**TOWN OF NEWBURGH  
PLANNING BOARD  
TECHNICAL REVIEW COMMENTS**

**PROJECT:** BARTON SITE PLAN/ LOT LINE CHANGE  
**PROJECT NO.:** 21-08  
**PROJECT LOCATION:** SECTION 97, BLOCK 2, LOT 27.32, 40 & 47  
**REVIEW DATE:** 8 JULY 2021  
**MEETING DATE:** 15 JULY 2021  
**PROJECT REPRESENTATIVE:** MECURIO-NORTON- TAROLLI-MARSHALL

Re: Job No. 3912-3  
Tax Map Parcels: 97-2-27.32, 40, & 47  
Town of Newburgh  
Orange County  
Auto Park Place & Unity Place  
Town Project #2021-08

**Landscaping Detail**  
SCALE: 1" = 20'

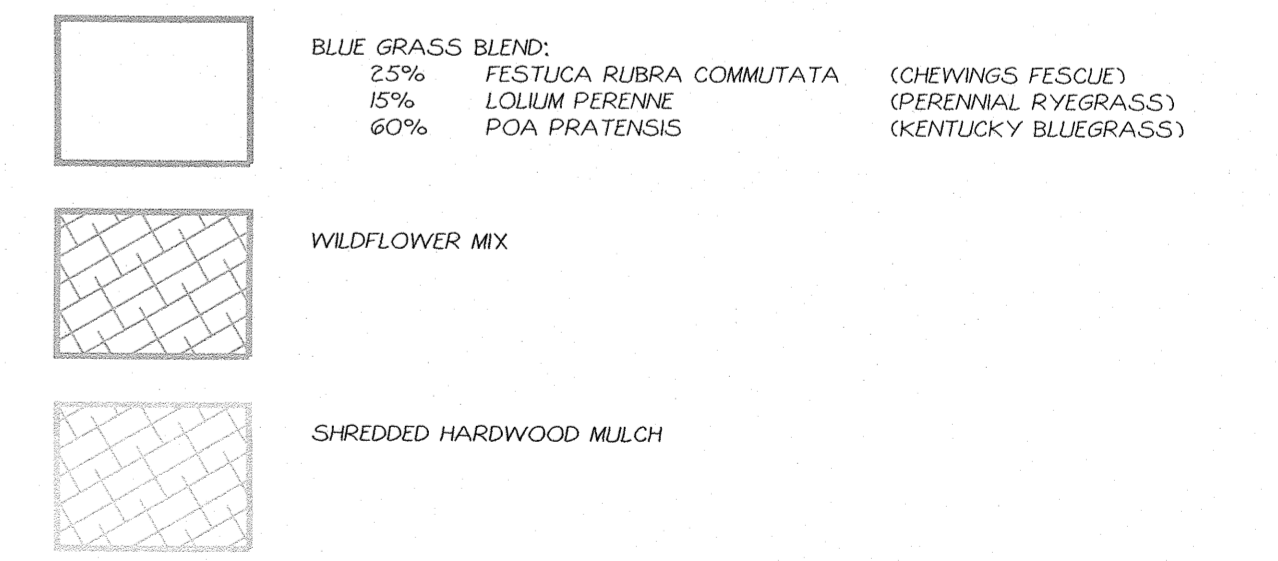
1. The previously proposed retaining wall has been removed. The southerly slope is proposed to be tied back to existing grade.
2. A landscaping plan has been included in the detailed site plan.
3. An updated building elevation, including exterior finish specifications, has been included in the current submittal. The exterior colors on the proposed addition will be consistent with the existing building.
